Remarks/Arguments

Serial No. 10/600,233

Amendment A

Reply to Office Action of June 15, 2004

FIG. 1

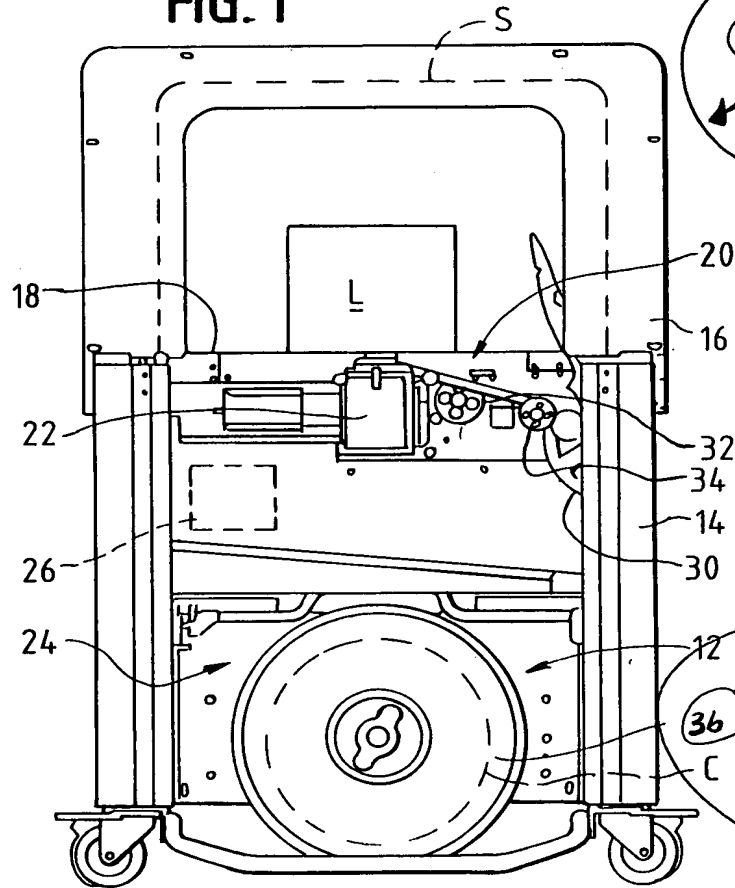
The Examiner objected to the drawings for a number of reasons. First, the Examiner objected to the drawings because they do not include the following reference characters included in the specification: 10 (strapping machine); 36 (hub); and 40 (top edge). Applicant has amended FIGS. 1-4 to show these reference numerals.

Next, the Examiner objected to FIGS. 1 and 3 because they include reference numeral 28, which is not mentioned in the specification. Applicant has amended FIGS. 1 and 3 to remove this inaccurate reference numeral, replacing it with 36, the correct reference number.

FIG. 3

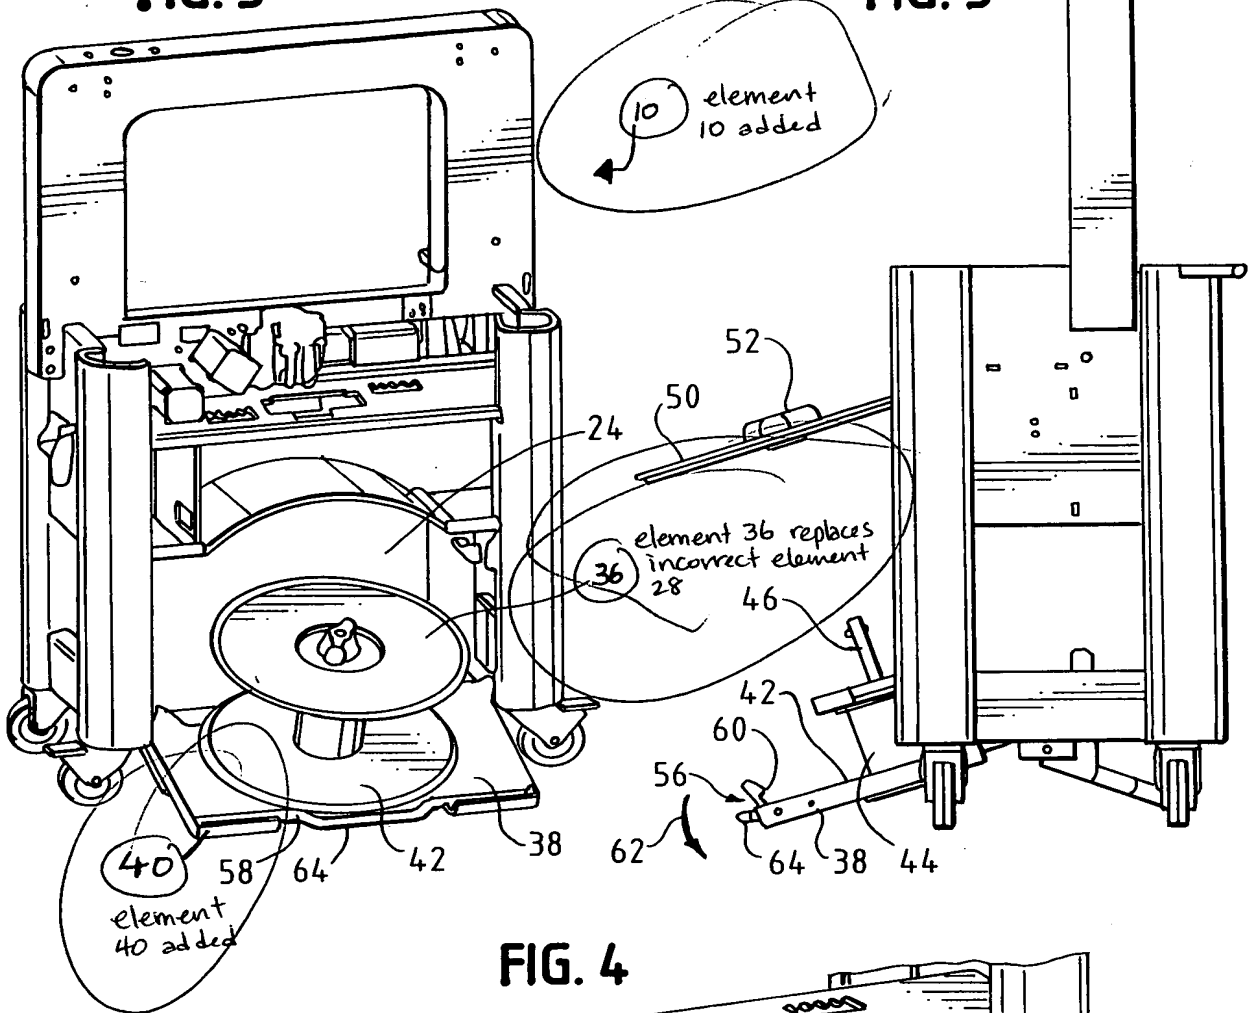
Finally, the Examiner objected to FIGS. 4 and 5 because they were photographs. As discussed above, Applicant has furnished replacement black ink formal drawings for FIGS. 4 and 5.
